Our Ref: 110608-03-The Maltings - Peer Review of Previous Civil/Structural Report

Attn: Gabrielle Chidiac
Subject: The Maltings – Review of Civil Engineering Report

Section 1.3 of ARUP's Report included a Site Plan showing the proposed buildings and site works which were proposed in the original Concept DA. An updated plan is provided on Plate 1-1 below for reference.

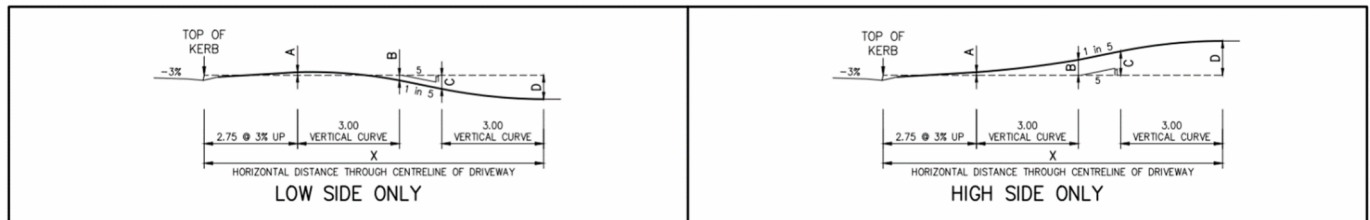
- The longitudinal gradient is suitable based on the maximum 1 in 5 grading specified in the Standard Driveway Gradings SD123 by Wingecarribee Shire Council.

- With reference to SD164 Private Road Residential Cross Sections by Wingecarribee Shire Council, the crossfall of 3% is suitable if the road is sealed, if unsealed the cross fall will need to be 6%.

- The proposed access roads will also need to consider roadside drainage as outlined in *4.6 Roadside Drainage, Austroads Guide to Road Design Part 3: Geometric Design 2021*, or *Standard Drawing Private Road Residential Cross Sections SD164*. In addition to managing the roadside drainage, it will need to follow Water-sensitive urban design in order to ensure the runoff is not damaging the surrounding environment.
